IDEA PUBLIC SCHOOLS – Mid Valley Building Envelope

ADDENDUM NO. 3

(ATTACHED: RFI from Argio Roofing with GMS Response. Responses included in the following addendum). Total Sheets = 23

BUILDING A
01 ROOF PLAN
SCALE: 3/32" = 1'-0"

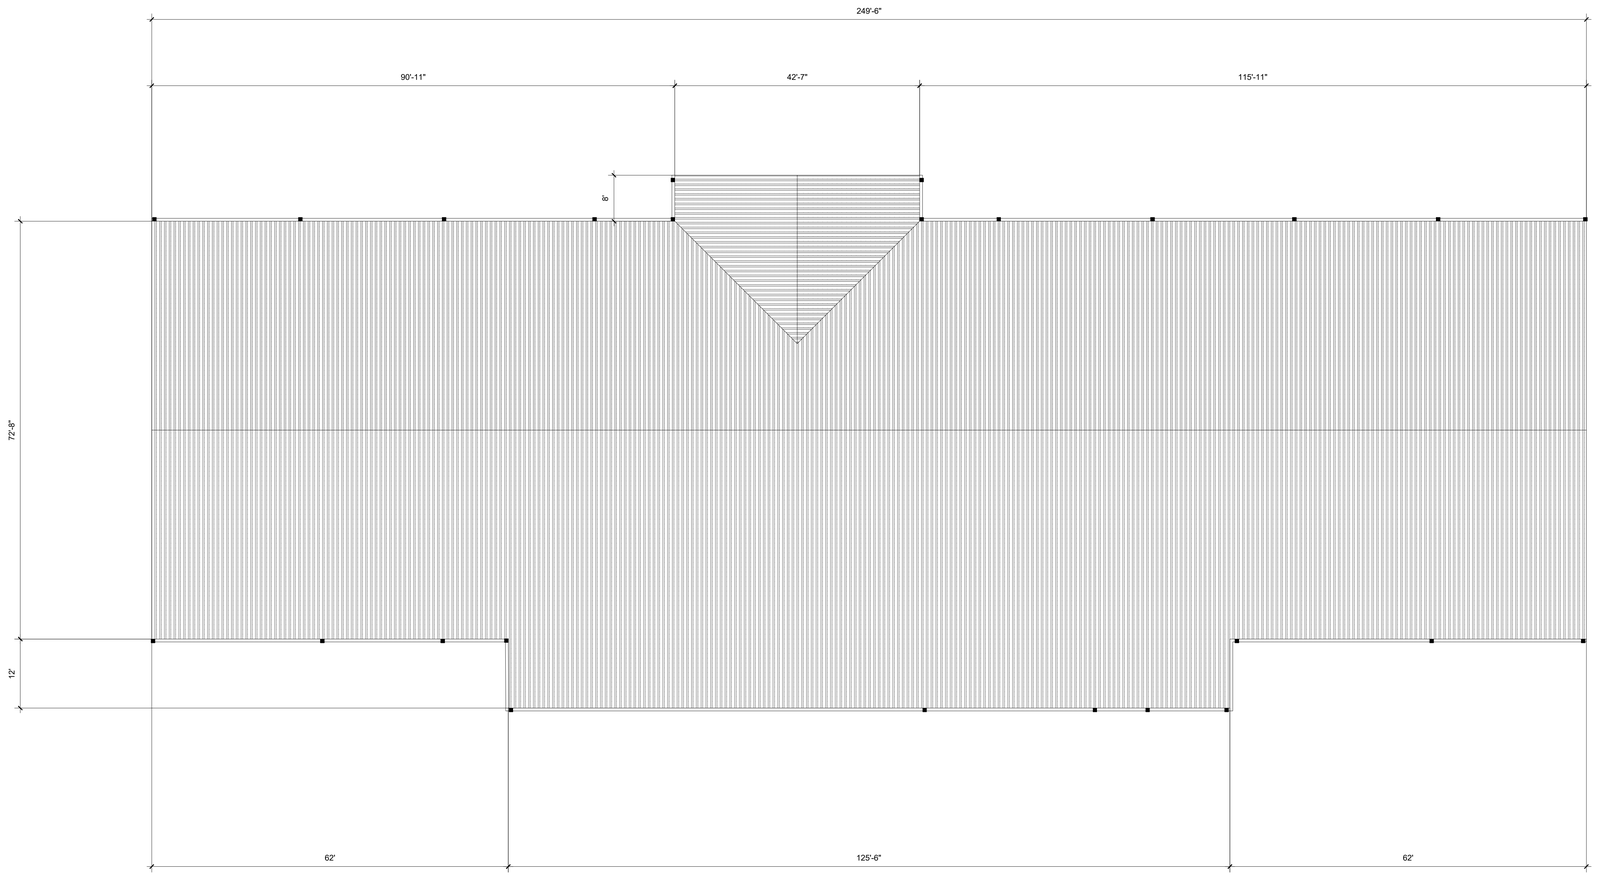
- Replace fasteners on all ridges and inside closures and provide new sealant between existing laps. Refer to updated notes on A2.00 sheets. This is on the “Roof Scope of Work” (Roof Sheets).

- Replace all boots on roof vents as well as their associated fasteners and sealant, refer to note on Roof Sheets.
- At all roof valleys, add new sealant between the valley flashing and roof panel.

- Ceiling tiles damaged during testing shall be replaced as required, refer to updated notes on Roof Sheets, please include allowance for replacement based on unit cost.

1. REPLACE ALL ROOF FASTENERS WITH NEW ONES THAT ARE ONE SIZE LARGER THAN INSTALLED
2. REPLACE ALL GUTTERS (MATCH EXISTING)
3. REPLACE ALL DOWNSPOUTS (MATCH EXISTING)
4. RESEAL LAPPED SHEET METAL AT RIDGES AND VALLEYS, AND INSIDE CLOSURES.
5. REPLACE BOOT FLASHING ON VENT STACKS, AND SEAL NEW FASTENERS

01 BUILDING D
ROOF PLAN
SCALE: 1/8" = 1'-0"

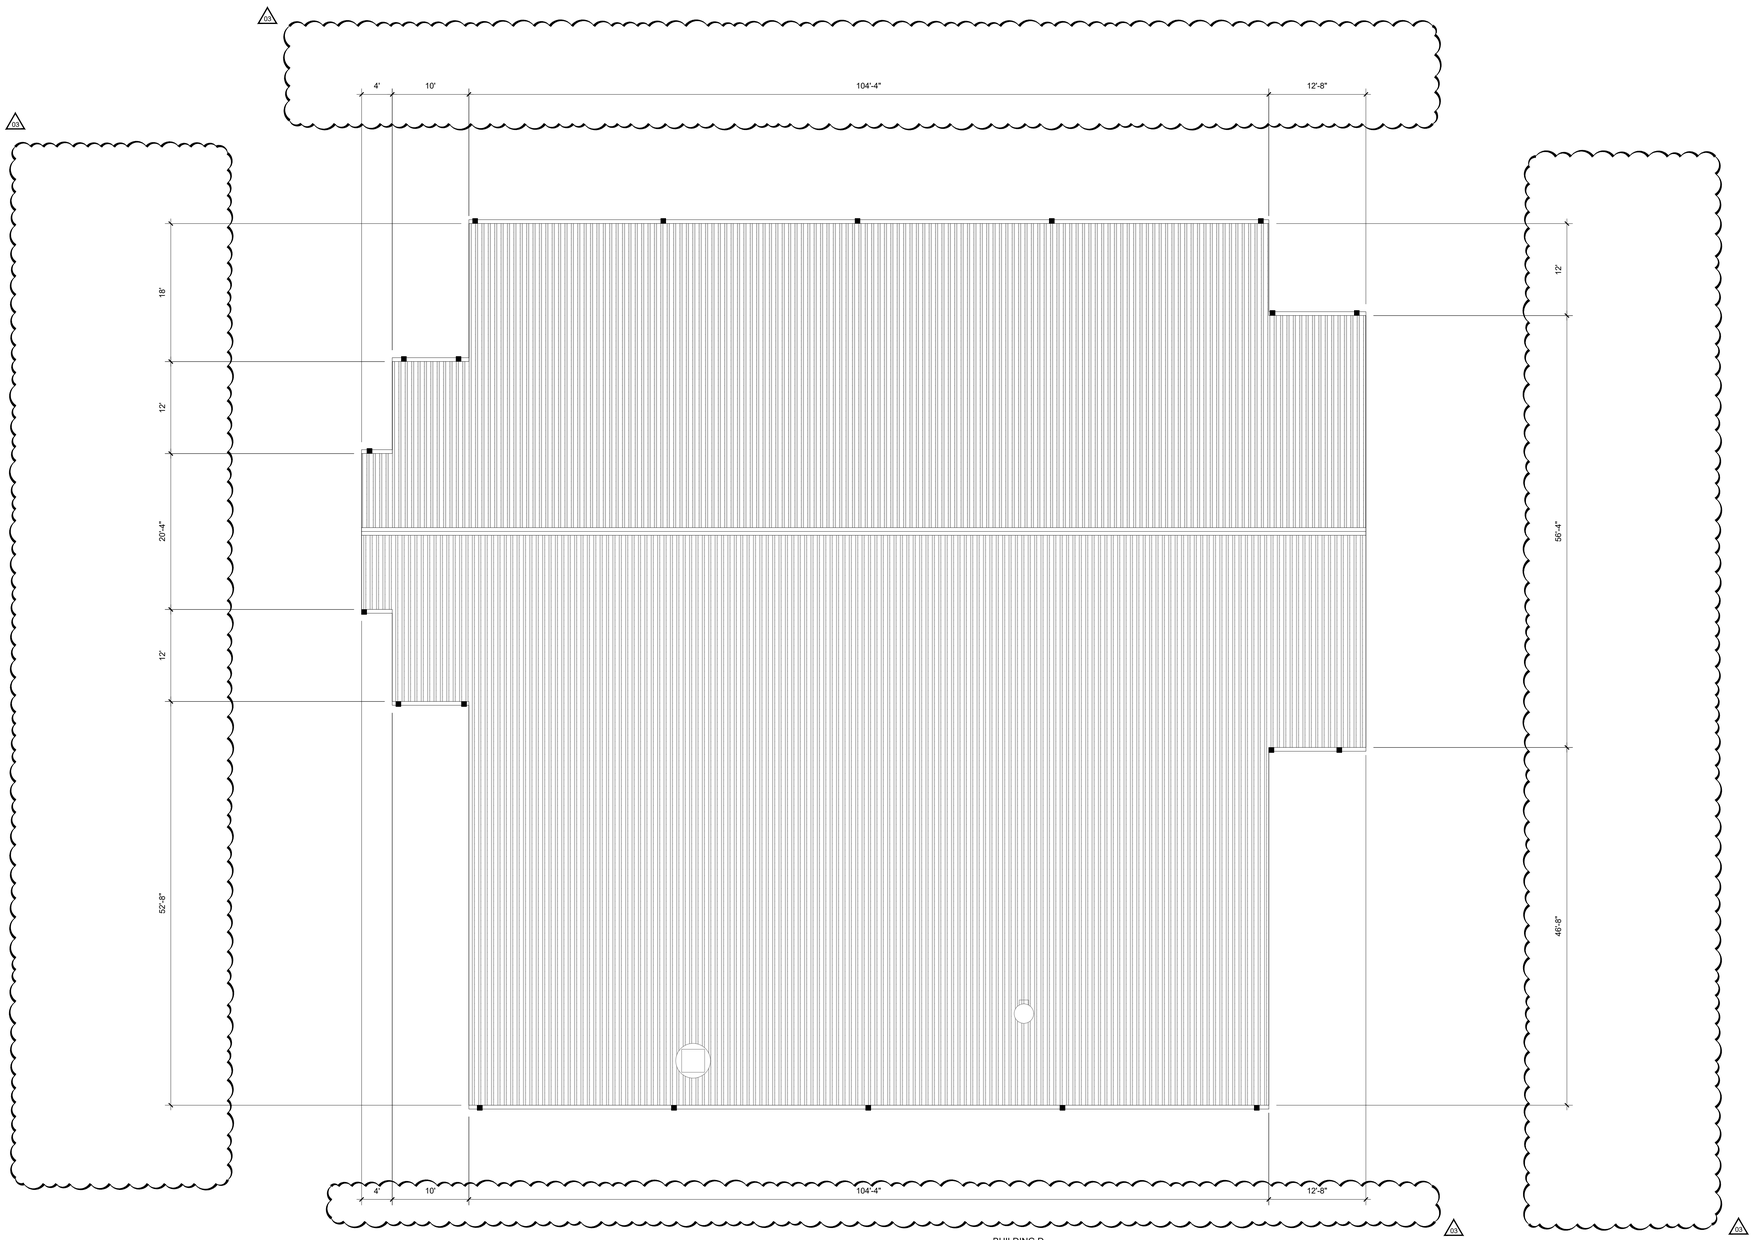
- Clarification: Dimensions corrected to be shown at scale of 1/8”=1’-0” on sheet A2.04

BUILDING A
01 WEST ELEVATION
SCALE: 1/8" = 1'-0"

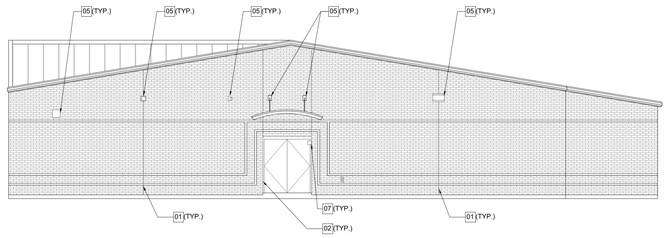
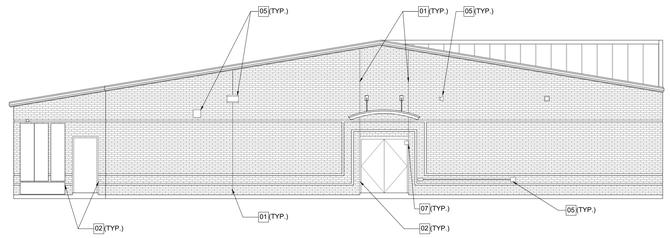
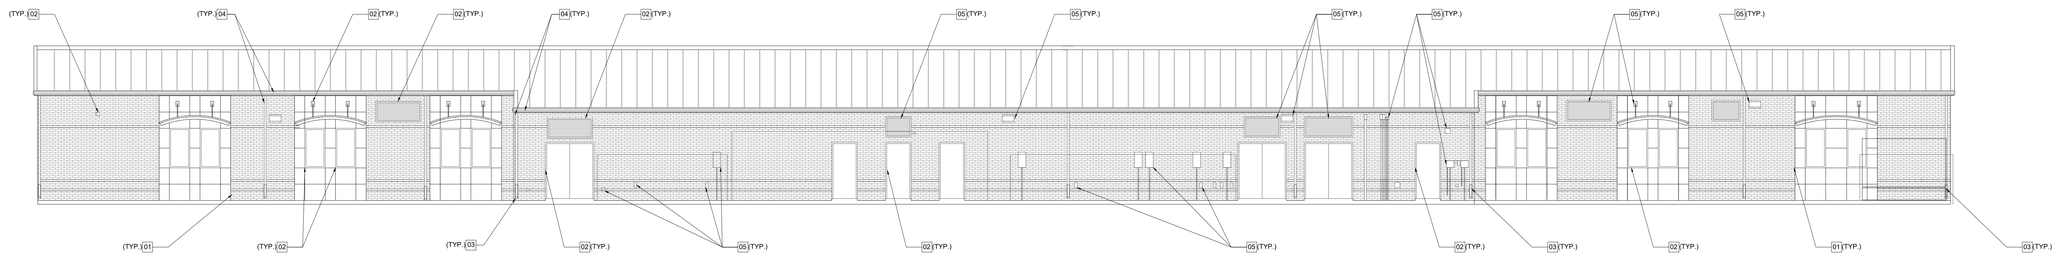
1. Do we need to replace the rake trims? No
2. Page A5.01 Keynote #3 calls for new boots, can you please provide a model type of boot you would like us to use? Also, on Scope of work Notes Item 1 states to match existing boots and currently there are none. Specification given, and note clarified

- Downspout Boots: Neenah Foundry Angular Downspout Shoes, field verify sizes.

01 OVERALL ROOF PLAN
SCALE: 1"=20'-0"

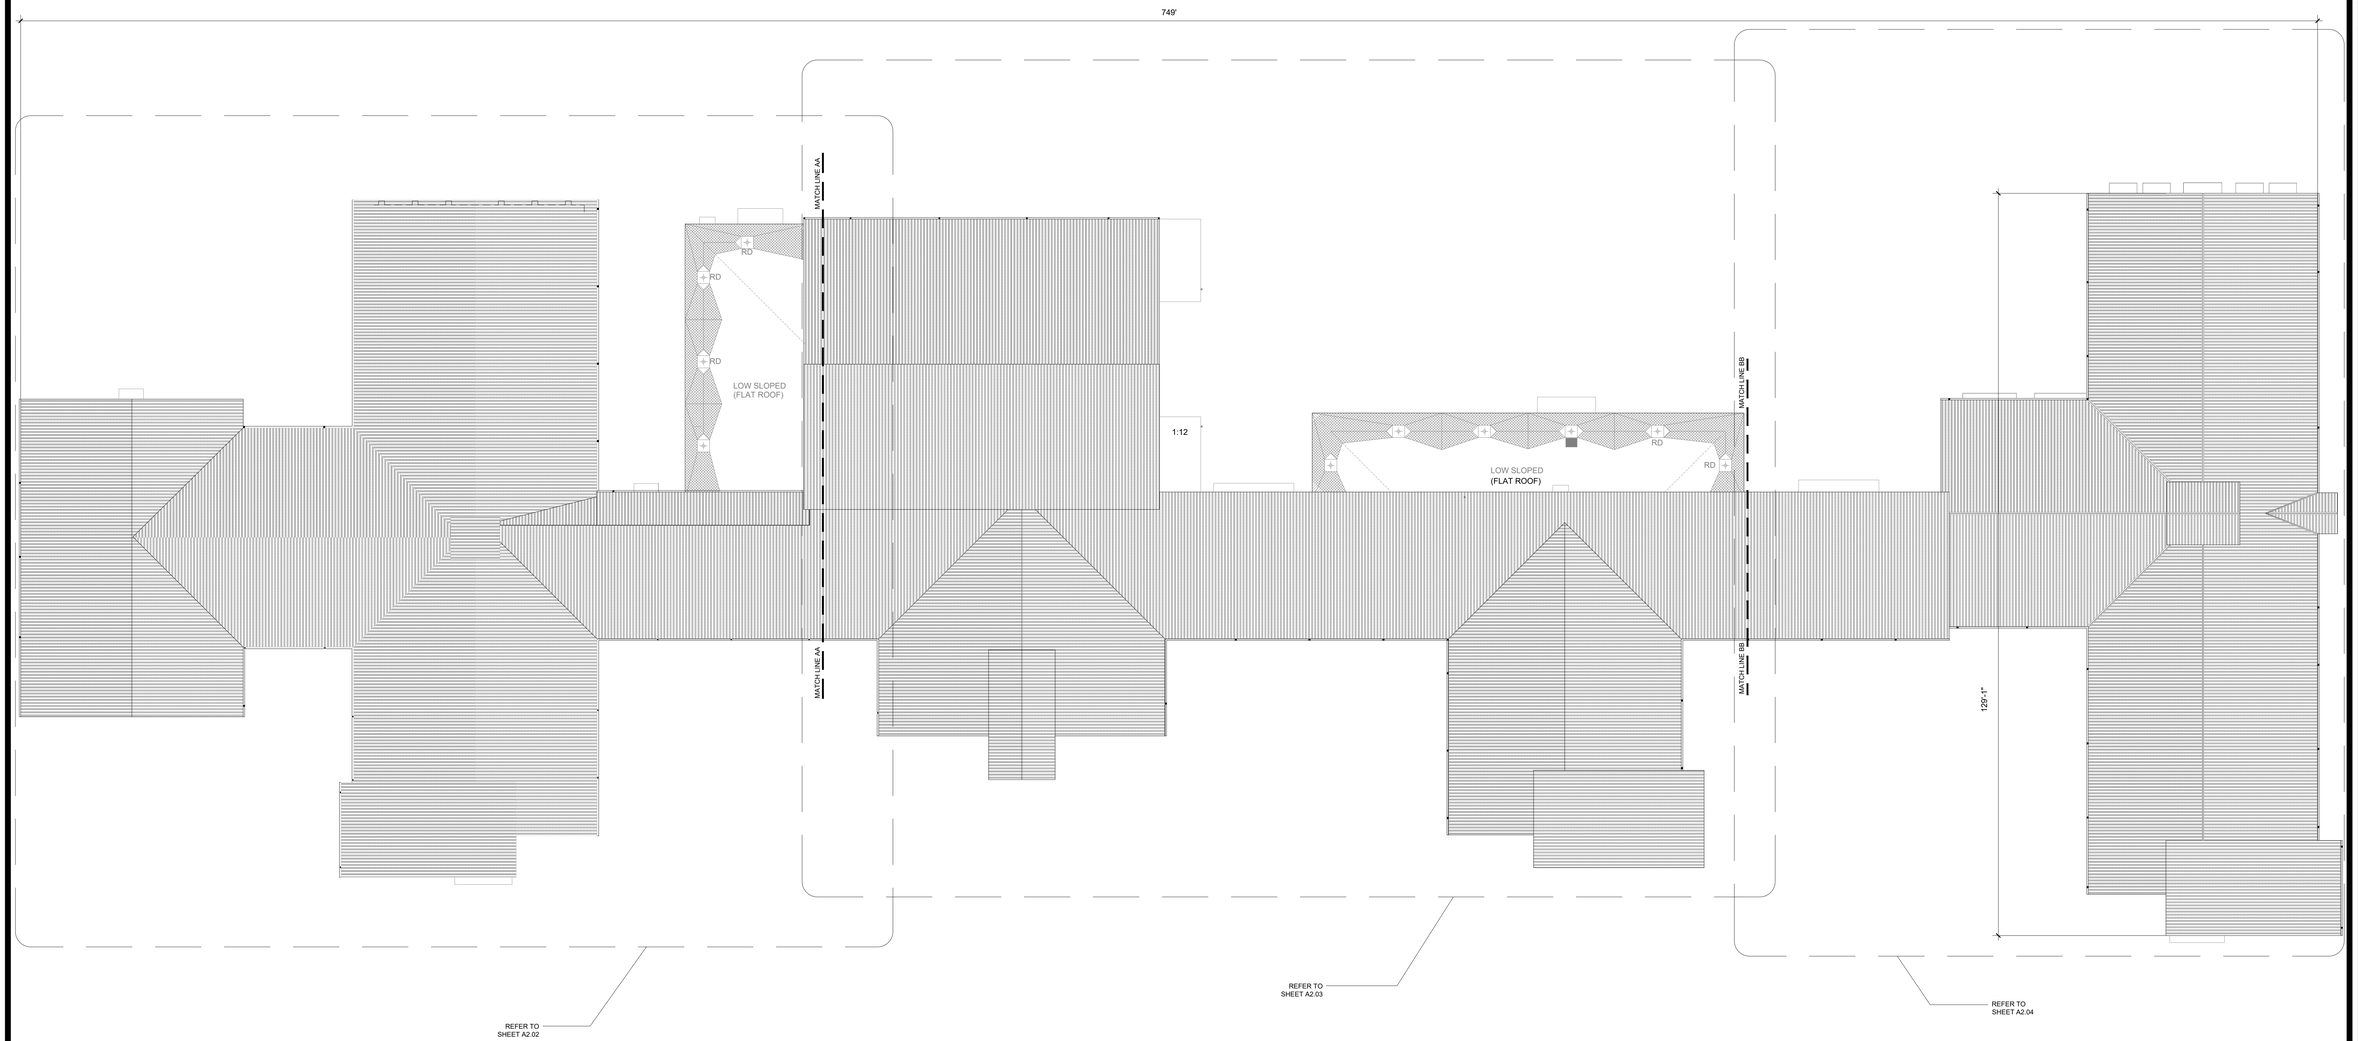
- On page A2.01, A2.02, A2.03 remove the existing roof access ladders.
- Provide new sealant between existing laps on ridges and valleys. Refer to updated note on “scope of work” note on roof sheets.
- Patch hole on roof panel, see sheet A2.03 for location.
- Downspout boots as specified below.
- Roof tiles damaged during testing shall be replaced as required, refer to updated general note on sheet A2.01.
- Clarification: Walkway pad redundant note removed, and existing reference to ladder removed.

1. REPLACE ROOFING IN AFFECTED AREAS AS NOTED
2. REFER TO SHEET A3.01 FOR DETAILS.
3. PURGE DRAIN LINES FROM ROOF LEVEL TO DISCHARGE POINTS.
4. PERFORM WATER TEST AT ALL ROOF DRAINS.
5. STRIP ROOFING MEMBRANE TO RECOVER BOARD.
6. INSTALL NEW MODIFIED BITUMEN ROOFING SYSTEM.
7. INSTALL NEW CAP FASCIA AND ACCESSORIES.
8. INSTALL WALKWAY SYSTEM TO/AROUND MECHANICAL UNITS, AND ROOF HATCHES. 03
9. PROVIDE CONCRETE SPLASH BLOCK AT EXTERIOR DOWNSPOUTS.
10. VERIFY FASTENER SIZE IS SUFFICIENT FOR NEW ROOF.
11. RESEAL LAPPED SHEET METAL AT RIDGES AND VALLEYS.
12. REMOVE EXISTING ROOF ACCESS LADDERS. 01

01 AREA "A" ROOF PLAN
SCALE: 3/32" = 1'-0"

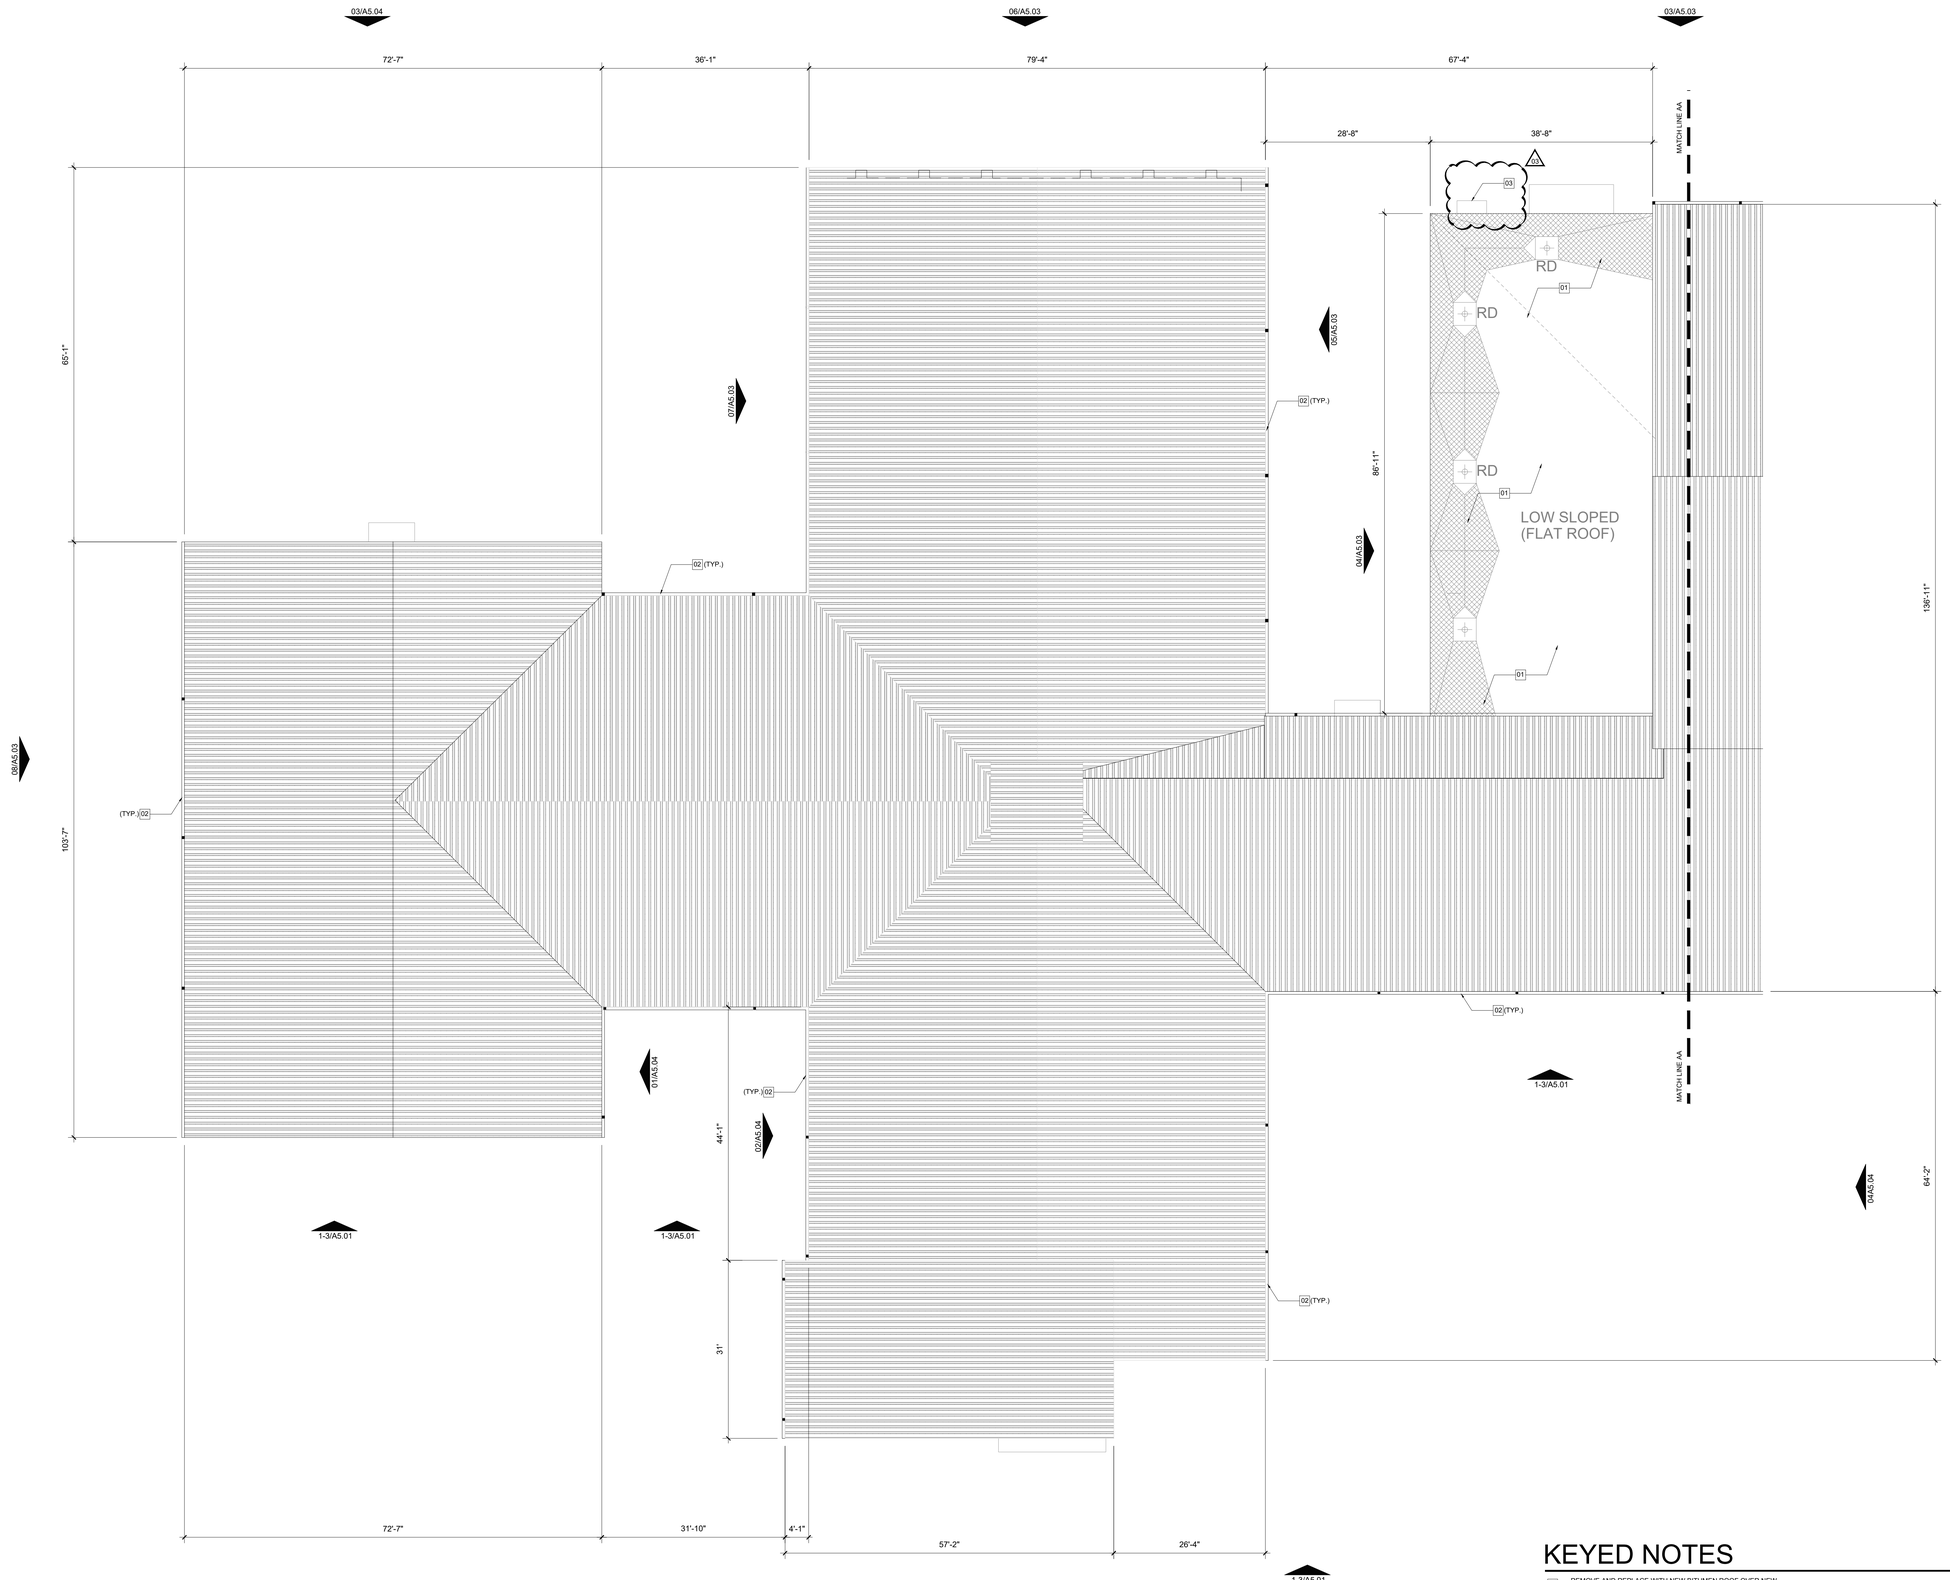
1. Page A2.02, at the flat roof, there is an existing ladder mounted on the side west south corner of the flat roof. The ladder is mechanically attached through the roof system. There is no proper flashing, do we remove the ladder? Do we modify and reinstall, or do we replace it with an appropriate ladder? Remove ladder

03 REMOVE EXISTING LADDER
